APPLICATION NO.	FILING DATE	FIRST NAMED INVENTOR	ATTORNEY DOCKET NO.	CONFIRMATION NO.	
10/690,760	10/22/2003	Remigijus Gaska	SETI-0005	5376	
23550	7590 01/21/2005		EXAM	EXAMINER	
HOFFMAN WARNICK & D'ALESSANDRO, LLC			NGUYEN, THINH T		
3 E-COMM S	-		ART UNIT	PAPER NUMBER	
ALBANY, NY 12207			2818		
			DATE MAILED: 01/21/200	DATE MAILED: 01/21/2005

K
	Application No.	Applicant(s)	1
Office Action Summan	10/690,760	GASKA ET AL.	
Office Action Summary	Examiner	Art Unit	
	Thinh T Nguyen	2818	
The MAILING DATE of this communication app Period for Reply	pears on the cover sheet with t	he correspondence address	
A SHORTENED STATUTORY PERIOD FOR REPL THE MAILING DATE OF THIS COMMUNICATION.  - Extensions of time may be available under the provisions of 37 CFR 1.1 after SIX (6) MONTHS from the mailing date of this communication.  - If the period for reply specified above is less than thirty (30) days, a repl If NO period for reply is specified above, the maximum statutory period Failure to reply within the set or extended period for reply will, by statute Any reply received by the Office later than three months after the mailin earned patent term adjustment. See 37 CFR 1.704(b).	136(a). In no

FIG. 2

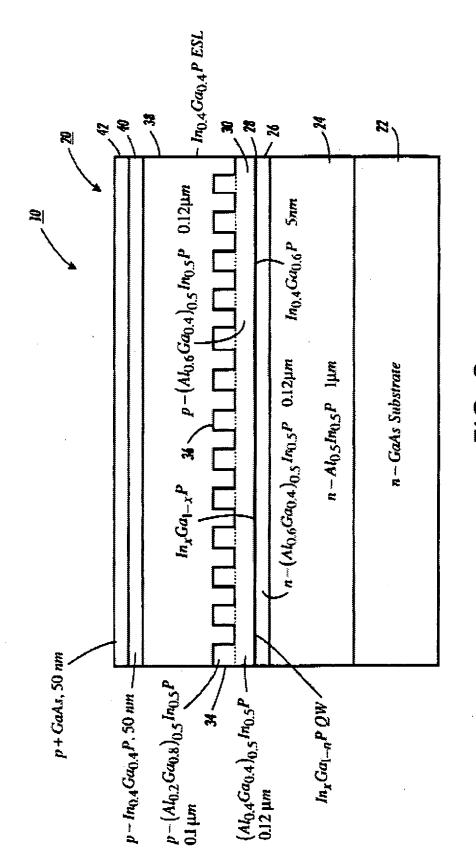
Sun (the abstract, fig 2) disclose a light emitting heterostructure comprising: a substrate (fig 2 layer 22) a light generating structure (fig 2 layer 28) formed over the substrate, a distributed semiconductor heterostructure Bragg reflector (DBR) structure formed (fig 2 reference 36) over the light generating structure; and a p-type layer (fig 2 layer 40) formed over the DBR structure.

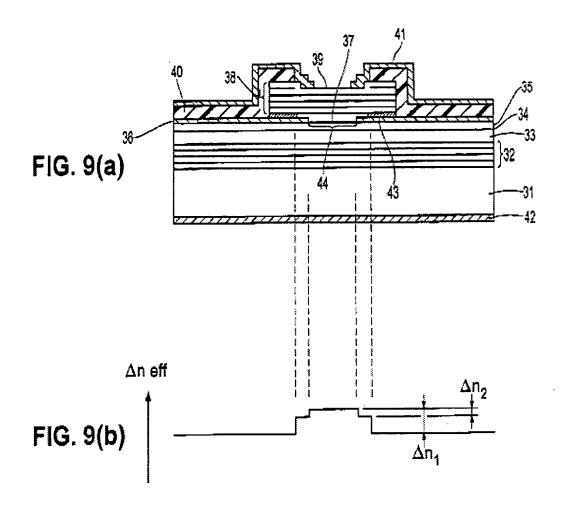
Similarly, Ueki (the abstract, fig 9 with substrate layer 31, Bragg layer 38, p layer 39) discloses the same invention.

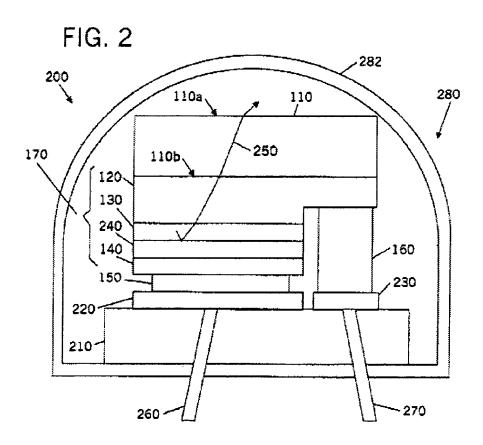
And similarly, Slater, Jr. (the abstract, fig 2 with substrate layer 110, Bragg layer 240, p layer 140) discloses the same invention. Noted that the device of Slater is flip-chip mounted that means it is mounted upside down.

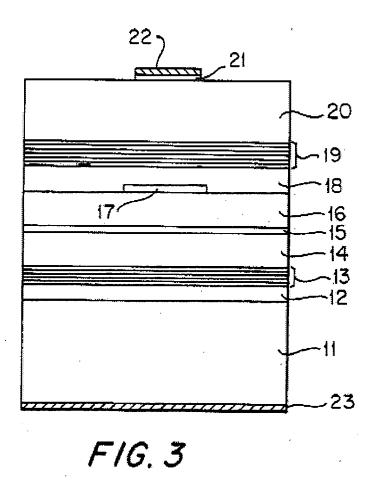
Sun (fig 2) disclose a n type layer (fig 2 layer 24) formed on the substrate with the light structure formed over the n layer.
